Subject: Arkansas Nuclear One - Unit 2
Docket No. 50-368
License No. NPF-6
Miscellaneous Information in Response to NRC Requests for Additional
Information Regarding the ANO-2 Power Uprate License Application

Fourth Request for Additional Information on Probabilistic Safety Assessment and ANO Responses Regarding the ANO-2 Power Uprate License Application

Fifth Request for Additional Information from Reactor Systems Branch Personnel (Long Term Cooling Analysis Performed at Power Uprate Conditions)

**Page D-16 through D-19 of Appendix D and Page E-1 through E-31 of Appendix E
of ANO-2 Radiological Dose Analysis for RSG and Power Uprate**

Figure 1

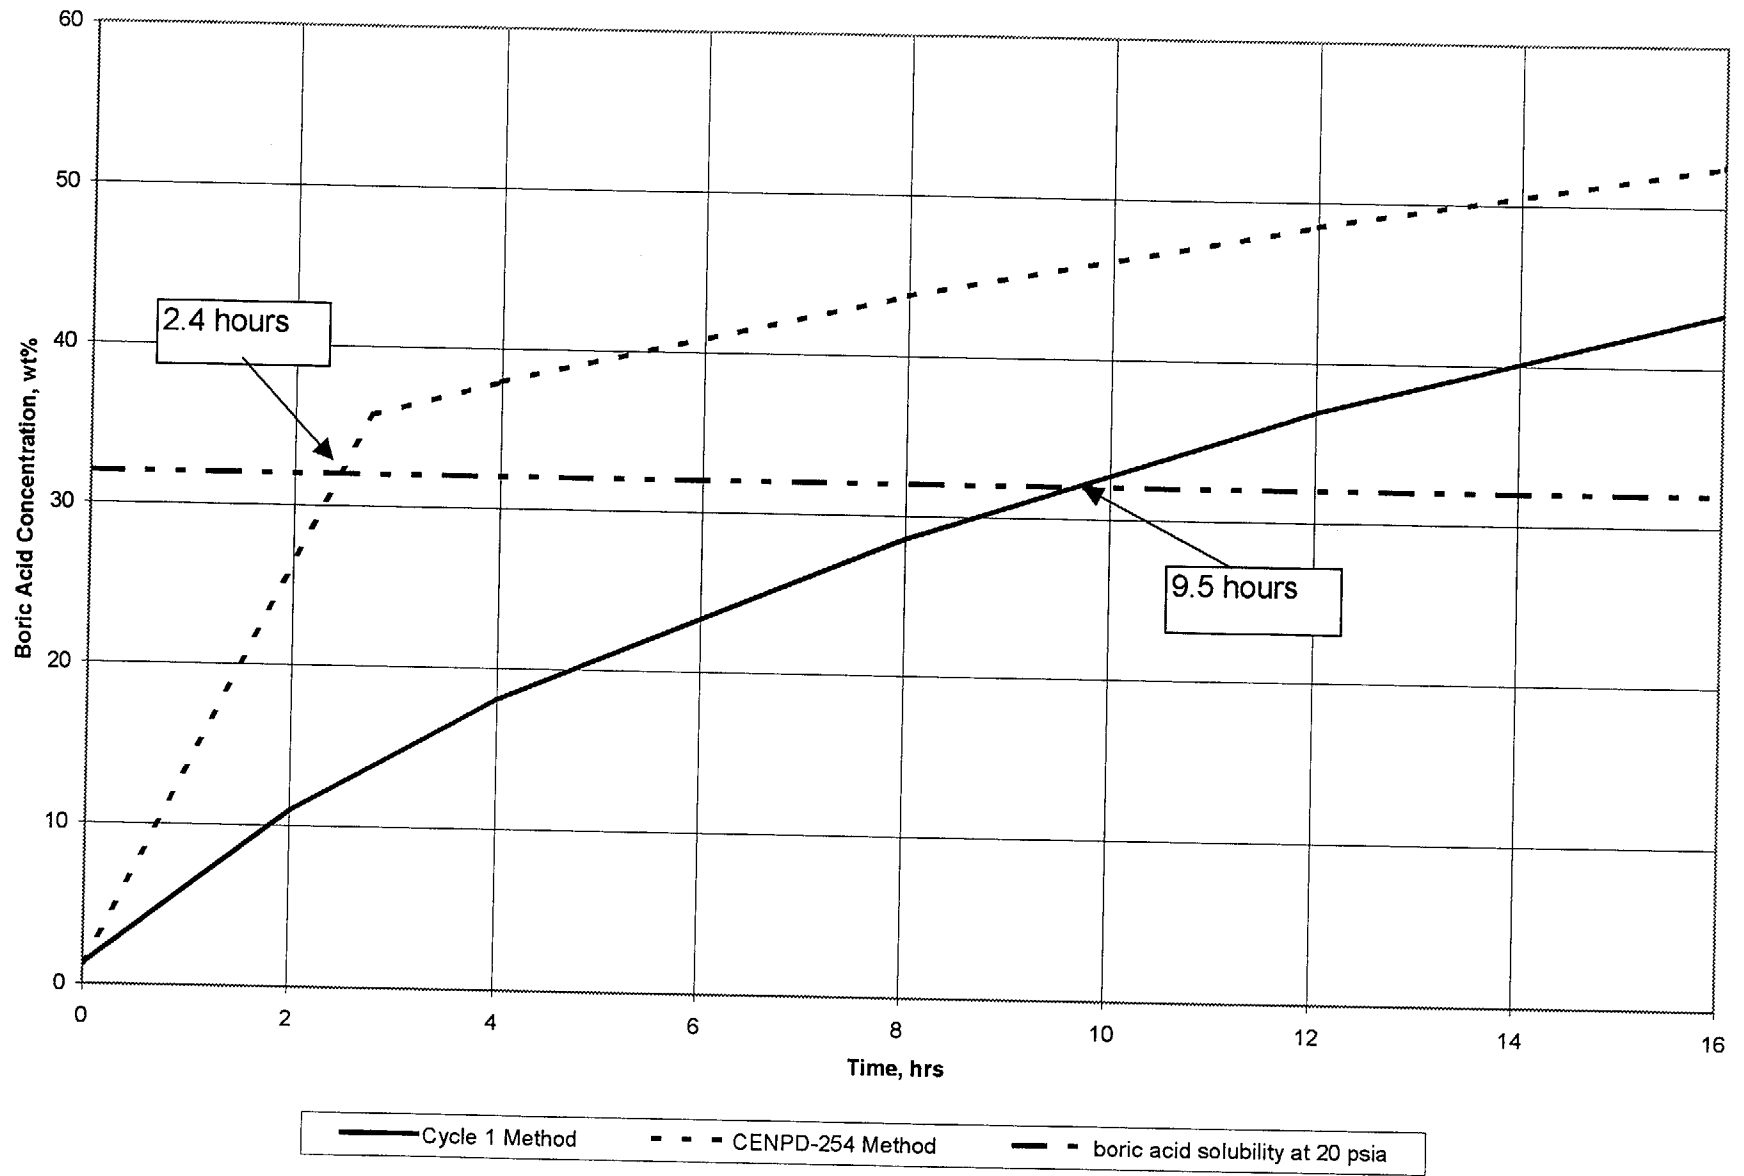
The boric acid precipitation evaluation model from CENPD-254-P-A, "Post-LOCA Long Term Cooling Evaluation Model," June 1980, is the methodology used for power uprate. Provide additional information to substantiate that this methodology is conservative and bounding.

The implementation of the BORON code in the ANO-2 long term cooling analysis increases the conservatism in the analysis methodology relative to the original methods employed at ANO-2. To demonstrate this conservatism, the BORON code was run using input assumptions consistent with the Cycle 1 analysis and the same solubility limit of 32 weight percent. Figure 1 reflects the results of a comparison of the original Cycle 1 method to the CENPD-254 BORON code method. As indicated in the figure, application

of the BORON code increases operational restrictions. BORON code results indicate that the solubility limit is reached within 2.4 hours versus the 9.5 hours using the Cycle 1 methods. This change in methods has significantly enhanced the conservatism in the long term cooling analysis for ANO-2. This same level of conservatism exists in the power uprate analysis results using the BORON code versus the Cycle 1 method. If the power uprate effort had been performed using the Cycle 1 methods, a comparable level of conservatism would be demonstrated between the BORON results versus the results using the Cycle 1 method.

Comparing the results in Figure 1 to those in Section 7.1.5 of the power uprate amendment request demonstrates that plant changes made to decrease potential boric acid injection from the BAM tanks offset the impact due to power uprate and significantly increased the time available for operator action. This change in boric acid concentration has also offset most of the impact of changing from the Cycle 1 method to the more conservative BORON code method and solubility limit discussed below. For power uprate conditions, the change in operator response time has been reduced from 9.5 hours

in the SAR to 7.3 hours by using the more conservative BORON code in conjunction with the reduced boric acid concentration. If comparable BAM tank boric acid concentrations had been assumed for power uprate conditions using the BORON code alone (i.e., no credit for concentration reduction), a response time less than the 2.4 hours cited above would have been calculated.
